CERTIFICATE OF APPROPRIATENESS

ITEM XXX
HPO File #: HP2026_0206

914 Main St
Landmark:

Proposal: Alteration – Repair and replace

SPANDREL REPAIR OPTIONS

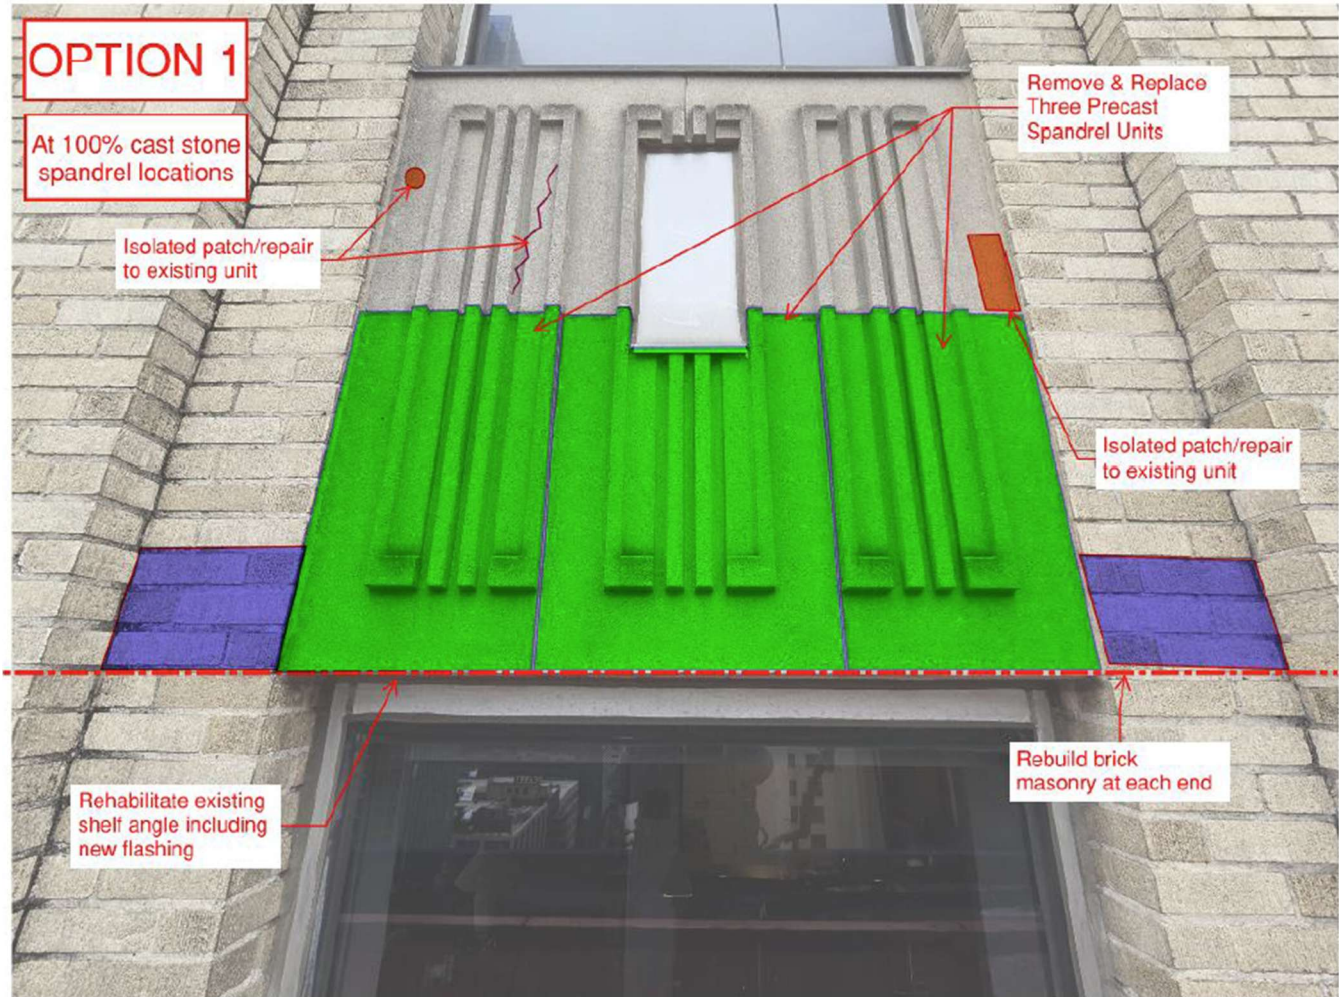
- Rebuild 100% of the cast stone spandrels from the 12th floor to the 25th floor.
- Repair/replace the cast stone spandrels at shelf angles utilizing the diagram depicted on the next page. This repair includes pinning the upper cast stone units in place to remove the lower three units resting on the steel shelf angles.

(HAHC to determine if Option 1 or Option 2 is recommended)

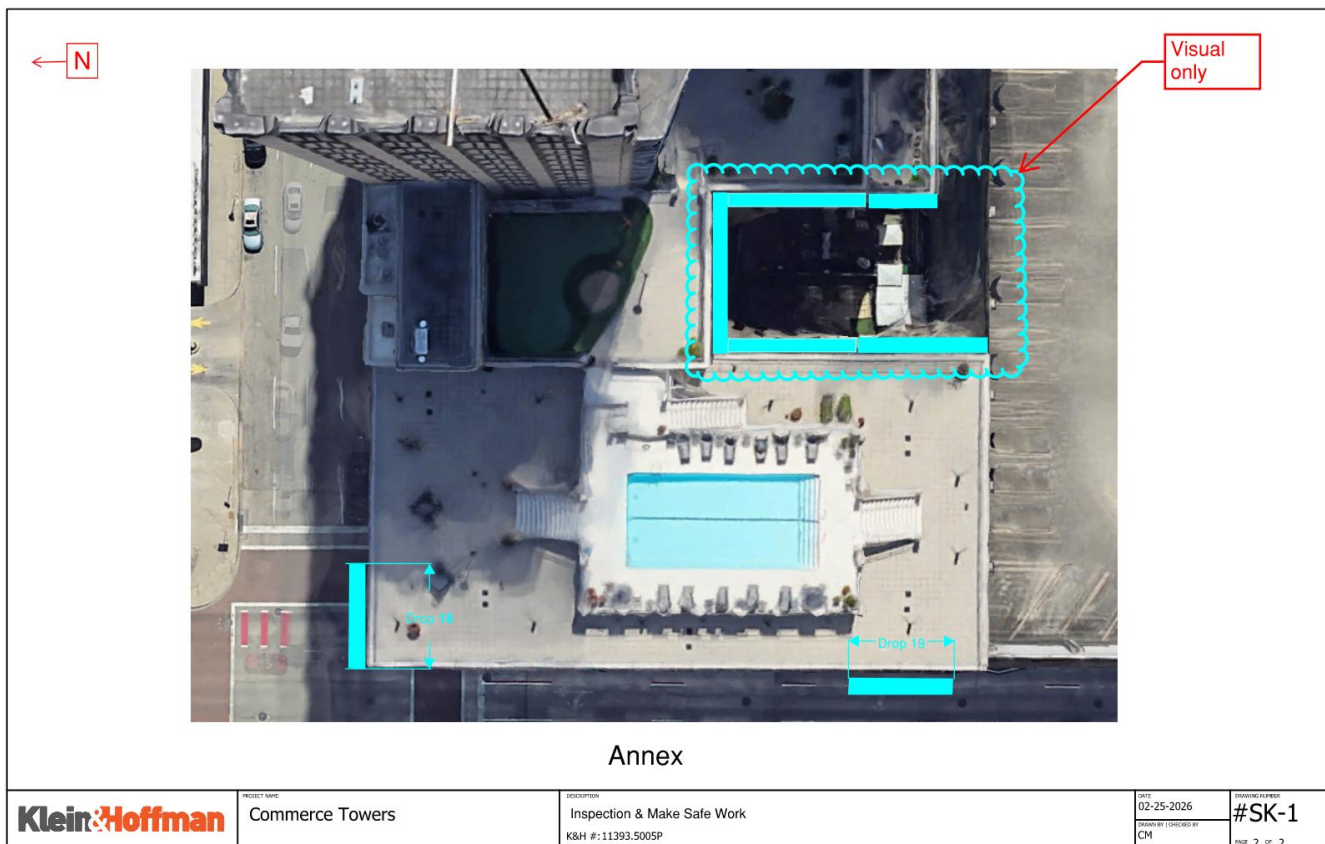
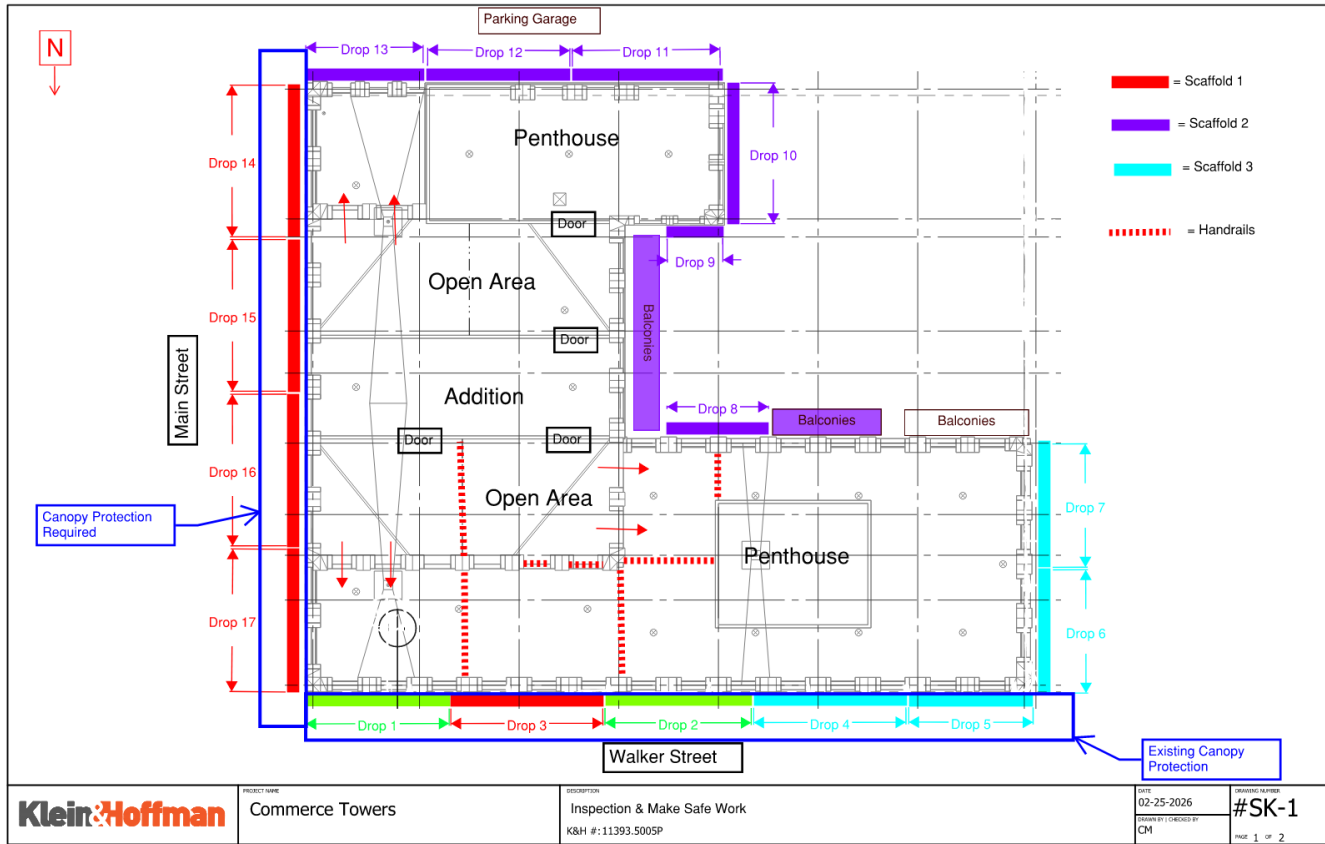
1. **Option 1:** At 100% of the cast stone spandrels, replace the lower three (3) cast stone units across the base of the spandrel and rehabilitate the shelf angle. The two (2) upper cast stone spandrel units will be pinned, stabilized, repaired as necessary, and remain in place. The shelf angle will be cleaned and painted with a rust inhibitive coating and new flashing system installed.

2. **Option 2:** Similar to Option 1, but only the cast stone units with visible deterioration will be replaced; the other cast stone units will be salvaged by removing and resetting. The two (2) upper cast stone spandrel units will be pinned, stabilized, repaired as necessary, and remain in place. The shelf angle will be cleaned and painted with a rust inhibitive coating and new flashing system installed. This option will require routine visual inspections via binoculars to review for additional spalling/deterioration at the reset/reused cast stone units.

3. **Option 3:** Similar to Option 2, but in lieu of performing the work at 100% of the cast stone spandrels, repairs will only be performed at cast stone spandrels with visible deterioration. This option will require routine visual inspections via binoculars to review for additional spalling/deterioration at the reset/reused cast stone units and at areas where rehabilitation of the steel shelf angles was not performed.

Photo No. 7. View of step cracks in brick masonry designated to be sealed. The cracking appears to stem from the embedded steel near the upper left corner of the image.

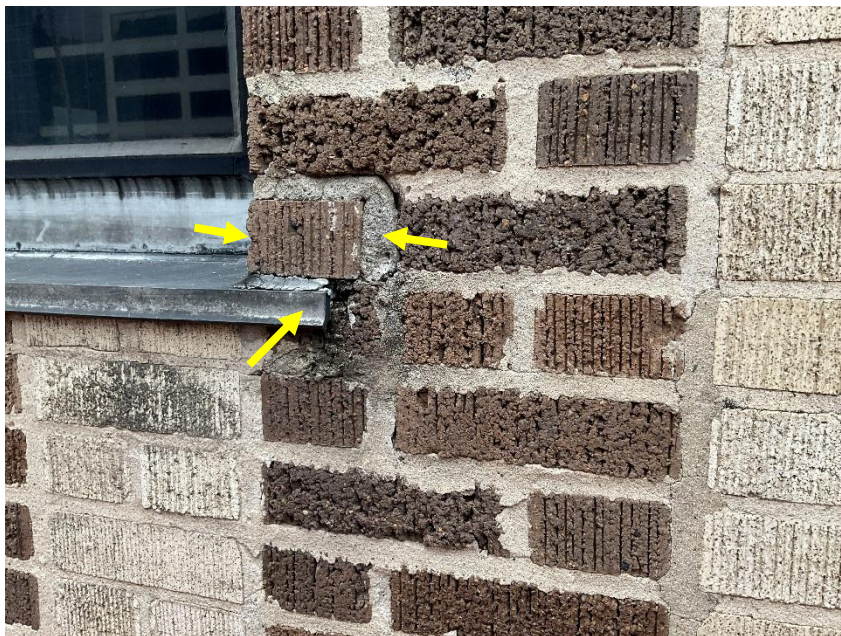
1. Isolated spalled brick and cracked brick masonry units were observed typically at the masonry piers immediately adjacent to the shelf angles, embedded steel elements, or window sills (Photo Nos. 7 – 8). Spalled and loose brick were removed and sealed. Individual spalled/cracked brick should be replaced and larger areas or spalled/cracked masonry are recommended to be rebuilt.
